GE Energy

MFN 06-213

Docket No. 52-010

Subject: **Information to Support Draft RAI 21.6-53**

Figure 4

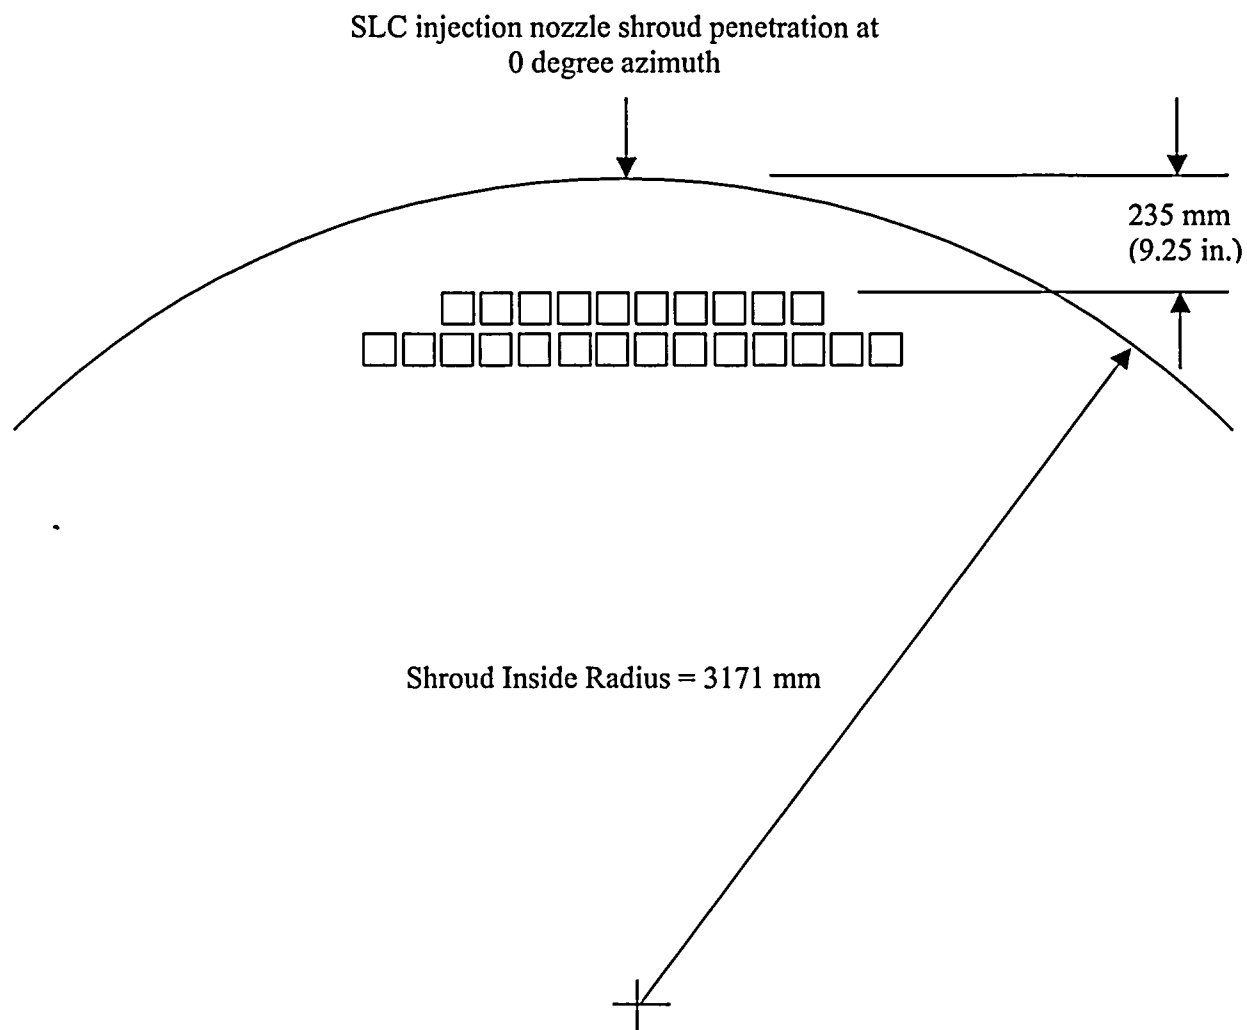
NRC RAI 21.6-53 - B (draft)

Geometry information (inner radius of the core barrel, flow areas for bypass region, flow area and loss coefficients from bypass region through the core support plate along with elevations of holes, flow area and loss coefficients for any flow paths from bypass region to lower plenum or fuel in general along with the elevations). Provide diagrams of the above showing the dimensions of the bypass along with the channel boxes. Supplement your illustrated response to RAI 21.6-29 with dimensions of all boron flowpaths through the lower tieplates, leakage holes and nose pieces of the fuel channels.

The inner radius of the core barrel can be found in the DCD Section 5.3, Table 5.3-3. The loss coefficients through the leakage holes between the bypass and the lower plenum and between the bypass and the channels are modeled in great detail in the ATWS TRACG model. The following data has been provided for convenience; for further detail, please refer to the TRACG User's Manual, the TRACG Model Description and ATWS basedeck. The flow areas and pressure losses across the holes are given in Figure 21.6-53b-1, from this the losses across the leakage holes can be calculated. The leakage paths between the bypass and the channels have been lumped together, as this is how the TRACG model models the leakage paths. Further detail of the shroud and fuel channel dimensions have been provided in Figure 21.6-53b-2 and 21.6-53b-3.
